PLAN APPROVAL REQUEST
 FACTORY BUILT STRUCTURES

Manufacturer **21FBS2400126**
ATCO Structures & Logistics M717-1
 Plans to be returned to: Address
115 Peacekeepers Drive SW
 City/State/ZIP
Calgary, AB - T3E 2A8
FOR DEPARTMENT USE ONLY
 Fee Ledg Sht # **110318937** Check # **FP4370590** \$ Amount **\$367.59** Application ID **FBS2400126**
 Ap No. **21FBS2400126** Date approved **12/9/2024** Expiration date **12/9/2025**

STATE OF WASHINGTON
DEPT. OF LABOR AND INDUSTRIES
FACTORY ASSEMBLED STRUCTURES
ELECTRICAL PLAN REVIEW

PROJECT:	28x64 ASL USA SR FLEET OFFICE WASH	DRAWING TITLE:	ARCHITECTURAL DRAWING LIST & GENERAL INFORMATION		
CLIENT:	CASCADE CHRISTIAN SCHOOL	PROJECT NO:	1107994	DRAWING NO:	AM001
			Exp. 12/09/2025	REV. #	B

DRAWING TITLE:	OVERALL POWER & DATA PLAN - LEVEL 1		
PROJECT NO:	1107994	DRAWING NO:	EM101
Exp. 12/09/2025		REV. #	B

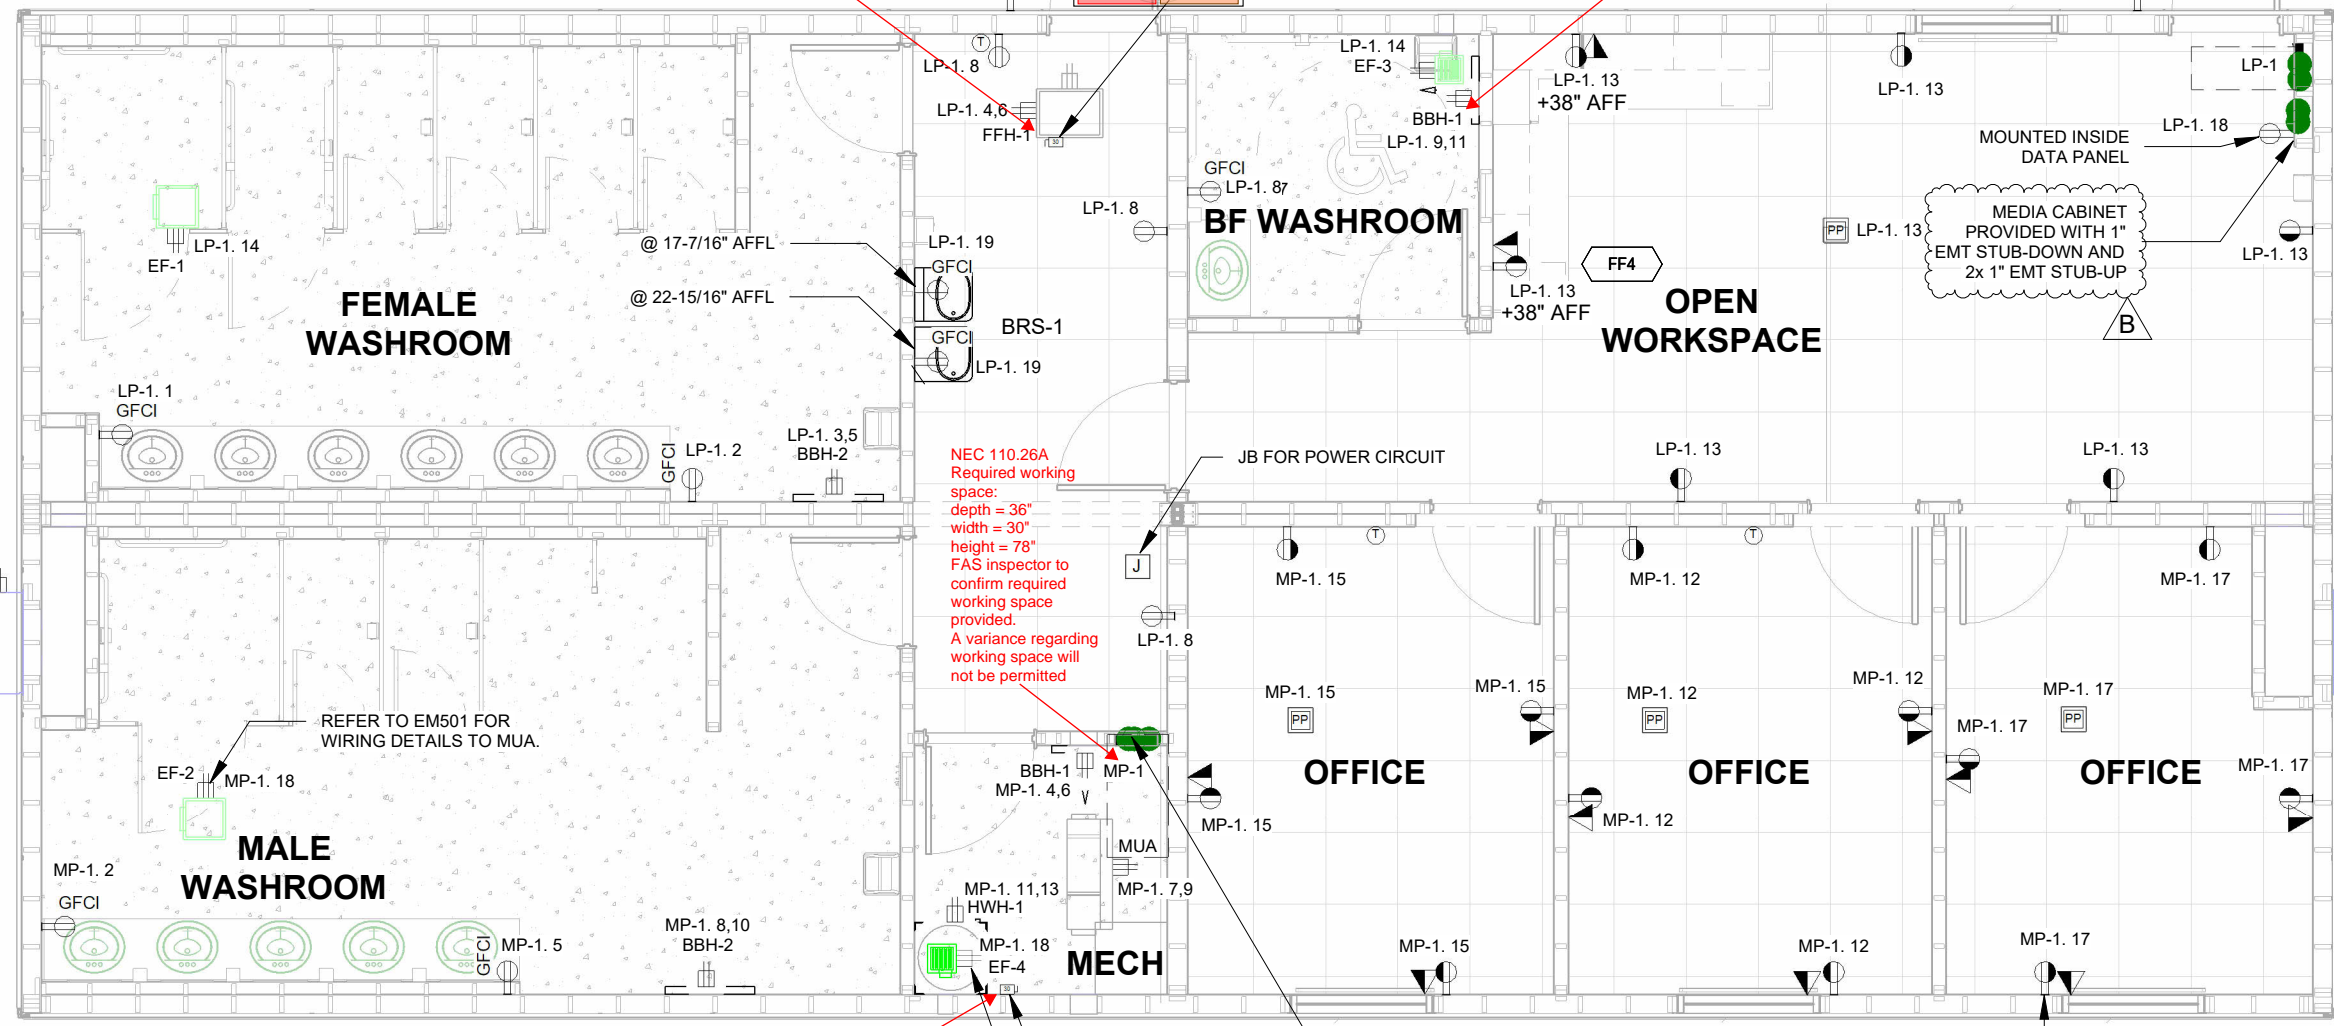
STATE OF WASHINGTON
DEPT. OF LABOR AND
INDUSTRIES
WAC 296-150F 0500
FAS PLAN REVIEW 10/22/24
Approval plates on disconnecting means
are to show designation of circuit source
panel board that supplies disconnect, circuit
numbers, and identify what it is disconnecting. Must
SUBJECT TO CODE
AND FIELD IDENTIFICATION PLATE. (Not a sticker)
Install identification plate on FFH-1 disc.

NEC 110.26A
Required working space:
depth = 36"
width = 30"
height = 78"
FAS inspector to confirm required working space provided.
A variance regarding working space will not be permitted

WAC 296.46B 110.022
Identification plates on disconnecting means are to show designation of circuit source panel board that supplies disconnect, circuit numbers, and identify what it is disconnecting. Must be an IDENTIFICATION PLATE. (Not a sticker)
Install identification plate on or adjacent to HVAC disconnect access panel (typ. all HVAC units)

1 HSS COLUMN BEAM CAP
SCALE: 3" = 1'-0"

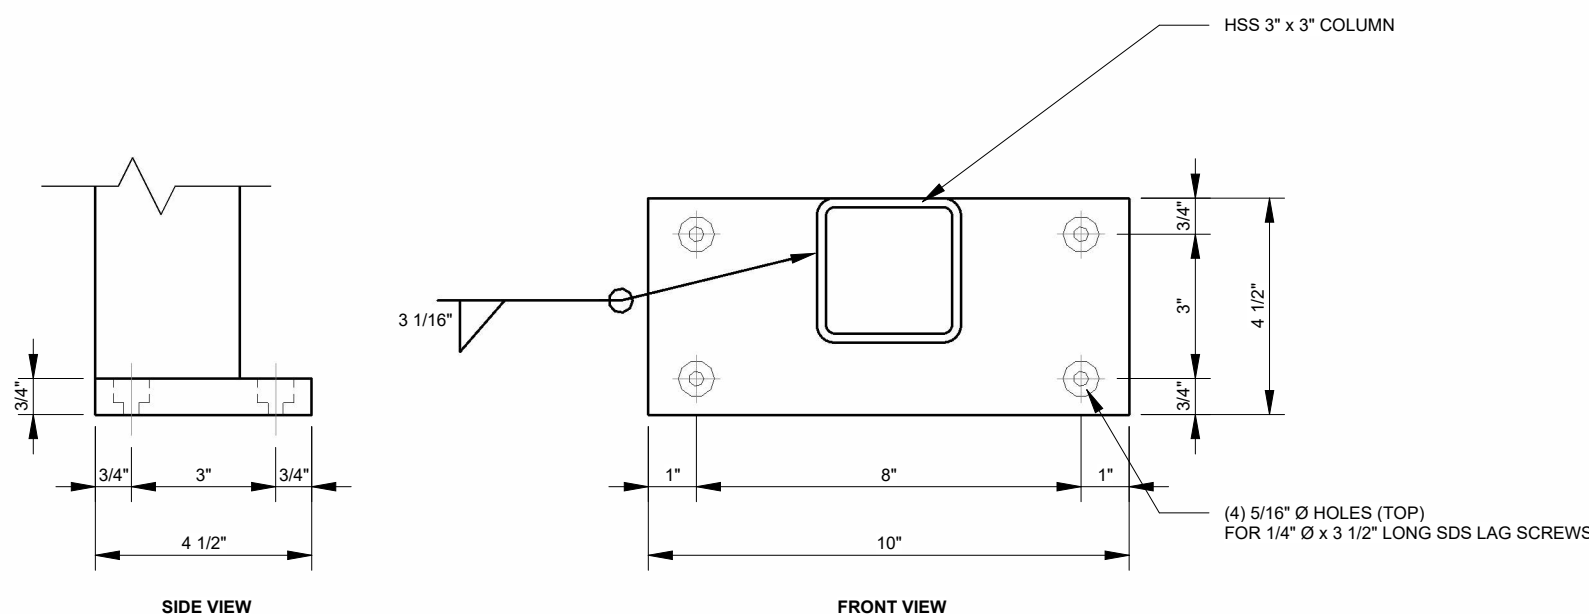
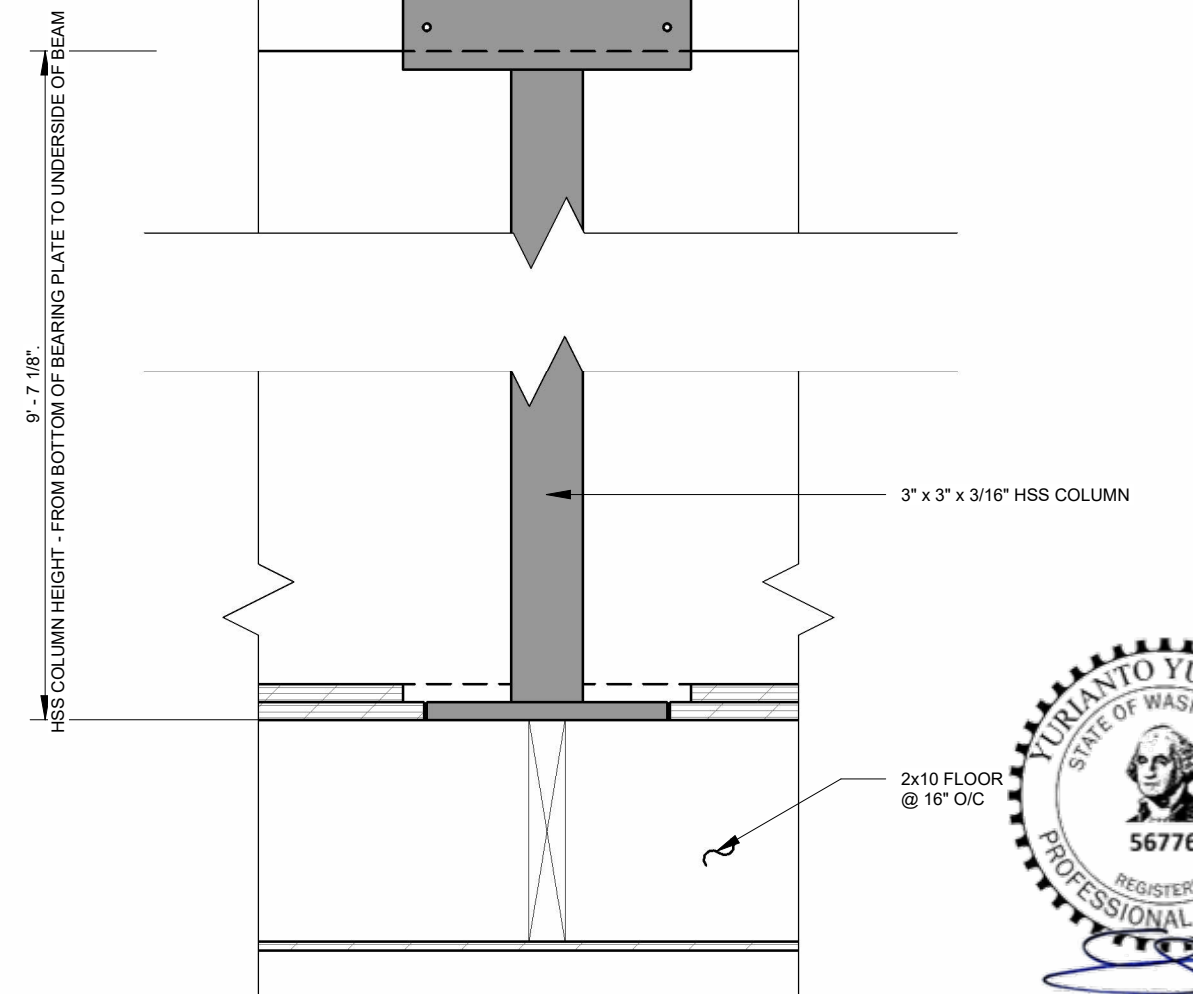
Special inspection required for all welding
